STANDARD DRAWING

RR-109 A

REQ.	ITEM	PART NO.	DESCRIPTION	SYMBOL
			THE TECHNICAL MATERIEL CORP. MAMARONECK. NEW YORK	
STOCK SIZE			TUBE, BALLAST	
MATERIAL		WEIGHT PER PC.		
TYPE & TEMPER			CD.D. 8-27-54	A. J. J. <i>WJC</i>
HEAT TREAT. SPEC.			DRAWN	ELEC. DES. APP. MECH. DES. APP.
FINISH & SPEC. NO.			CHECKED <i>faw</i>	FINAL APPROVAL A. J. J.

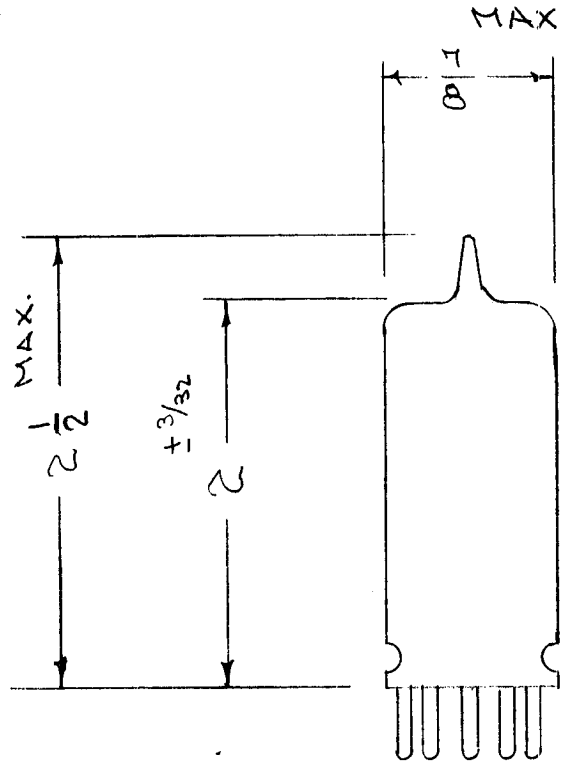
A	2 1/2 MAX. WAS 2 3/8, 4.3V WAS 3.9	12-18-64	13104	HCA	<i>[Signature]</i>	<i>[Signature]</i>	
ISSUE	ITEM	CHANGED FROM	DATE	CN. NO.	DRAFTS	CHECKER	ENG. APP.
TOLERANCES			SCALE				
ALL OTHERS	DEC. DIM. ± FRAC. DIM. ± ANGULAR DIM. ±	DRILL, PUNCH, COMMERCIAL STOCK SIZES AND MANUFACTURERS TOLERANCES ARE NOT INCLUDED.
